ACCESS 2022 A2 & ADAPTABLE HOUSING INDICATIVE COMPLIANCE REPORT FOR DA LODGEMENT

**251-257 Maroubra Road &
133 Garden Street,
Maroubra NSW 2035**

Prepared for:	BWSLD Maroubra Pty Ltd
Project No.:	PRO-09979-Z1Q1
Date:	09/03/2026
Status:	Report Issue v1.1

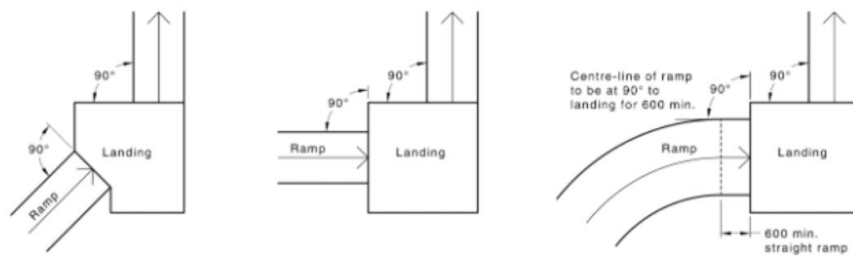
Sufficient turning spaces and dead end zones appear to have been provided within accessways required to be accessible in accordance with AS1428.1-2021, with the exception of numerous turning spaces within Basement 1, Ground Floor, and the Eighth and Ninth Floor residential corridors of Building B.

Compliance can be achieved via slight redesign prior to the issue of the Construction Certificate.

Figure 4 First Floor Adaptable Units Location on Architectural Plans

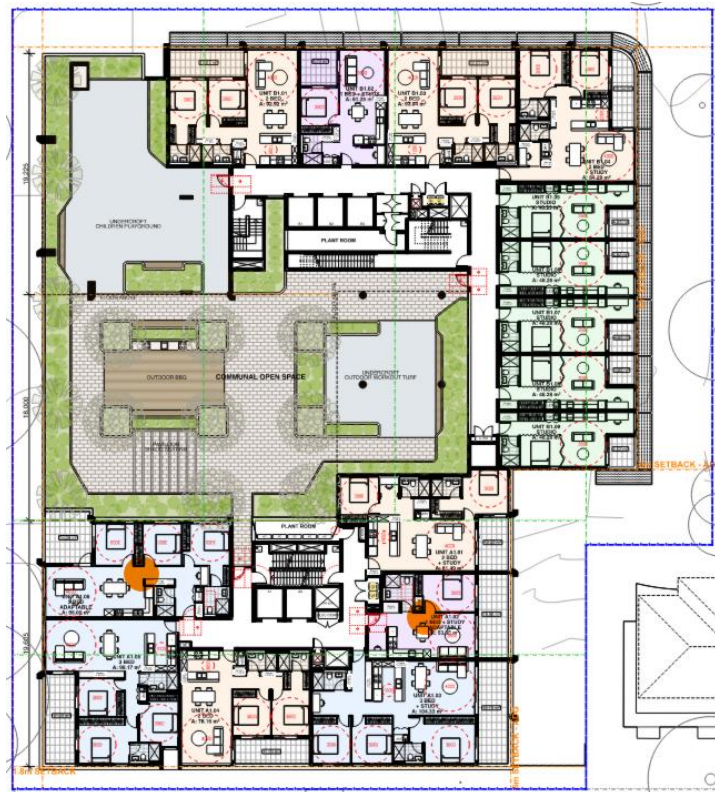
- Unit A1.02;
- Unit A1.06;
- Unit A2.02;
- Unit A2.06;
- Unit B2.01;
- Unit B2.12;
- Unit B2.13;
- Unit A3.02;
- Unit A3.06;
- Unit B3.01;
- Unit B3.12;
- Unit B3.13;
- Unit A4.02;
- Unit A4.06;
- Unit B4.01;
- Unit A5.05;
- Unit B5.01;
- Unit A6.05;
- Unit B6.01;
- Unit A7.05;
- Unit B7.01;
- Unit A8.03;
- Unit B8.01; and
- Unit B9.01.

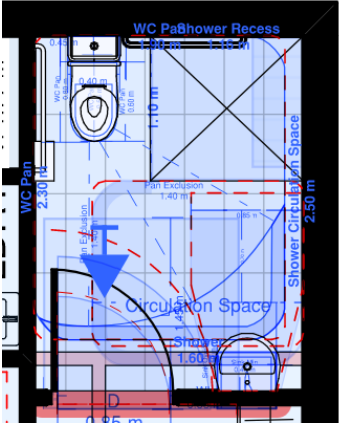
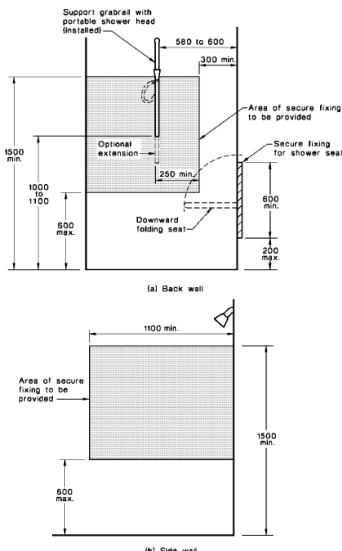
Post adaptive fixtures and circulation spaces are to comply with the required dimensions of AS1428.1-2021 (blue) or element(s) requiring review (red) for the designated units:

Bathroom			
Item	Status	Item Description	References
		 Recommendation: Compliance can be achieved via slight redesign prior to the issue of the Construction Certificate.	
76	CRA	Slip-resistant floor surface <i>Floor surfaces shall be slip-resistant to comply with AS/NZS 3661.1.</i> <i>Note to be added to plans prior to issue of the Construction Certificate.</i> <i>Design verification to be provided prior to the issue of the Construction Certificate.</i>	Clause 4.4.2 - Floor Surface
77	CRA	Shower recess-no hob. Minimum size 1160 x 1100mm to comply with AS 1428.1 (Refer to Figures 4.6 and 4.7 of AS 4299-1995)  (a) Back wall (b) Side wall DIMENSIONS IN MILLIMETRES FIGURE 4.6 REINFORCED AREAS FOR SUBSEQUENT INSTALLATION OF GRABRAILS IN SHOWER COMPARTMENTS  Where bath is to be retained after modification DIMENSIONS IN MILLIMETRES FIGURE 4.7 REINFORCED AREAS FOR SUBSEQUENT INSTALLATION OF GRABRAILS AT BATHS <i>Shower compartment A shower shall be provided. The shower compartment shall be a minimum size of 1160 x 1100 mm. The soap holder shall be recessed. The position of the shower head and taps shall be such that the clearances and heights required by AS 1428.1 are achieved.</i> <i>Provision for this item appears to be indicated on the post-adaption plans as illustrated in Item 75.</i>	Clause 4.4.4(f) - Shower Compartment
